Access Compliance Report

Public Rights-of-Way

(Curb Ramps)

Intersection ID: 49133	Main Street: EWERT_CUT_LN	Cross Street: AMBER_LEIGH_WAY_DR	Location: SE
ADA ID: 90AEDD896229	Ramp Type: Perp	Initial Pass/Fail: Pass	Overall Compliance: No
Severity Score: 0			
Codes/Mitigation Info/Possible Solution		Field Measurements/Component Compliance

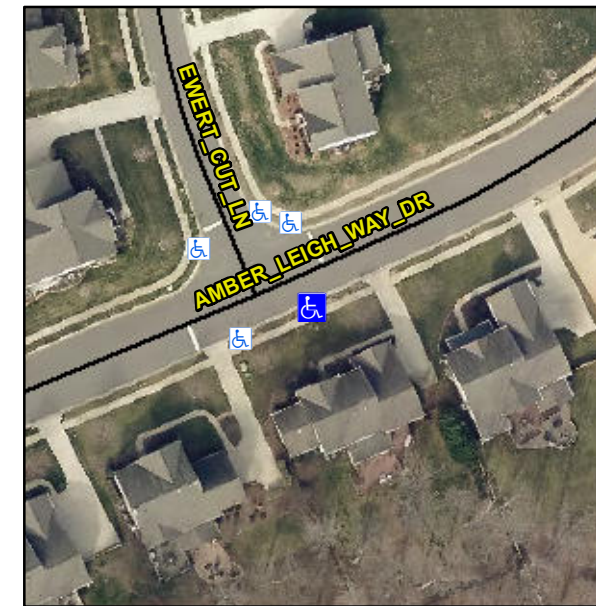
R304.2.1, R304.2.2-Perp, R304.3.2-Para, R305.2

Compliance	Description	Data	Compliance	Description	Data
N/A	Ramp Length (in)	47.0	Yes	Ramp Slope (%)	7.6
Yes	Ramp Width (in)	48.5	Yes	Ramp XSlope (%)	0.1
N/A	Flare Type LT	Sloped	N/A	Flare Type RT	N/A
N/A	Flare Slope LT (%)	8.3	Yes	Flare Slope RT (%)	7.9
N/A	Flare Traversable LT?	Yes	N/A	Flare Traversable RT?	Yes
No	Landing Length (in)	47.5	Yes	DWS Provided?	Yes
Yes	Landing Width (in)	48.5	Yes	DWS Contrast?	Yes
No	Landing Slope (%)	2.1	Yes	DWS Length (in)	24.5
Yes	Landing X Slope (%)	0.3	Yes	DWS Full Width?	Yes
N/A	Landing Curb? (Y/N)	No	No	DWS Offset (in)	3.5
N/A	Shared Landing?	No			
Yes	Gutter Ponding?	No	Yes	Gutter Slope (%)	2.7
Yes	Gutter Lip Ht (in)	0.0	Yes	Gutter X Slope (%)	0.3
N/A	Painted X Walk1?	No	N/A	Painted X Walk2?	N/A
	X Walk 1 Direction	To N		X Walk 2 Direction	N/A
N/A	X Walk 1 Width (in)	N/A	N/A	X Walk 2 Width (in)	N/A
	X Walk 1 Slope (%)	3.6		X Walk 2 Slope (%)	N/A
	X Walk 1 X Slope (%)	0.7		X Walk 2 X Slope (%)	N/A

N/A	Ramp inside XWalk1?	N/A	N/A	Ramp inside XWalk2?	N/A
	Road Slope (%)	N/A	N/A	Clear Space?	Yes
	Road X Slope (%)	N/A	N/A	Clear Space to XWalk (in)	N/A
Yes	Any Obstructions?	No	Yes	Storm Grate/Utility Hazard?	No
	Obstruction Type			Storm Grate/Utility Type	
		N/A			N/A
			Yes	Surface Condition? (G/P)	Good

Remove & Replace Entire Ramp.
